Recall Campaign Bulletin

Campaign No. 2023070012, May 2024

Revision G: 09/03/2024

Replace Fuel Pump Delivery Module – Wave 6

Figure 2

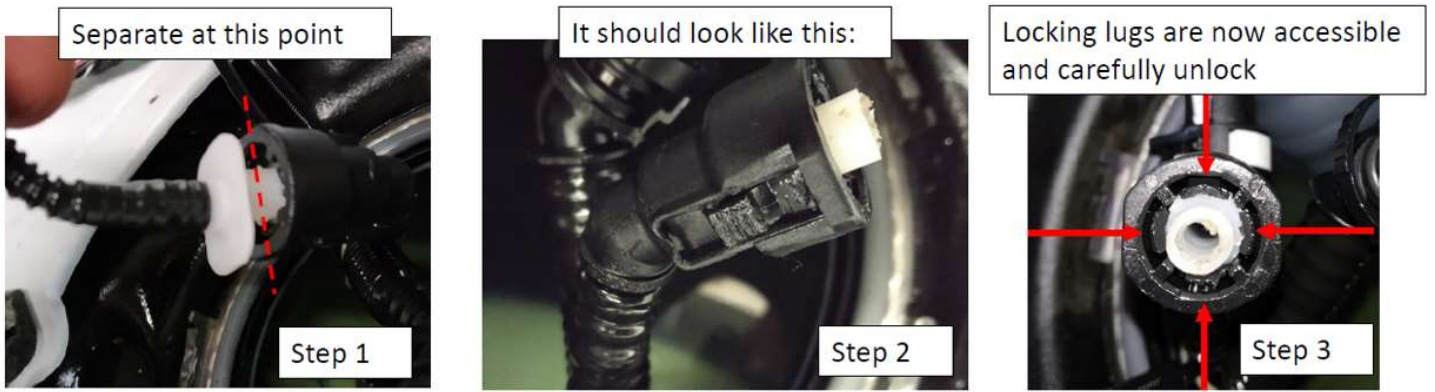
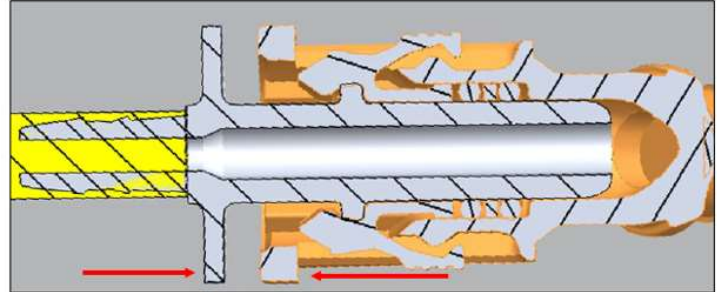
i Only model 206, 232: Note on disassembly of suction jet pump drive line quick connector. The procedure step 1-3 should only be performed when the quick disconnect is not working (Figure 2).

MRA2 Quick Connector suction jet pump drive line

Squeeze the QC connection by at least 1mm, then unlock the latching lugs. If this is not possible. Step 1 -3

Figure 3 (release corresponding connector and disconnect the contacts)

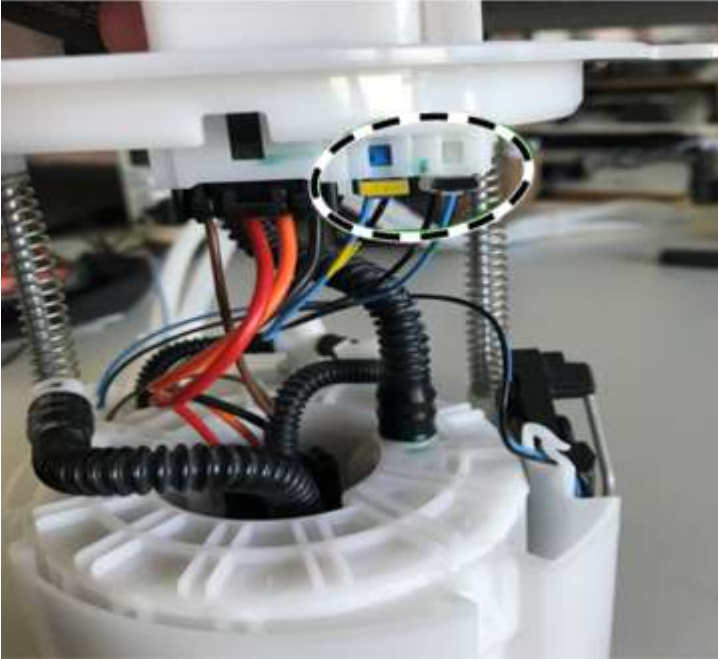
i Delivery modules that are delivered **without float-and-lever sensor** must be modified. (Figures 3-5)

Figure 4 (remove lines from routing clip)

Figure 5 (using a screwdriver, carefully push float-and-lever sensor housing away from module housing and at the same time push float-and-lever sensor housing upwards.)
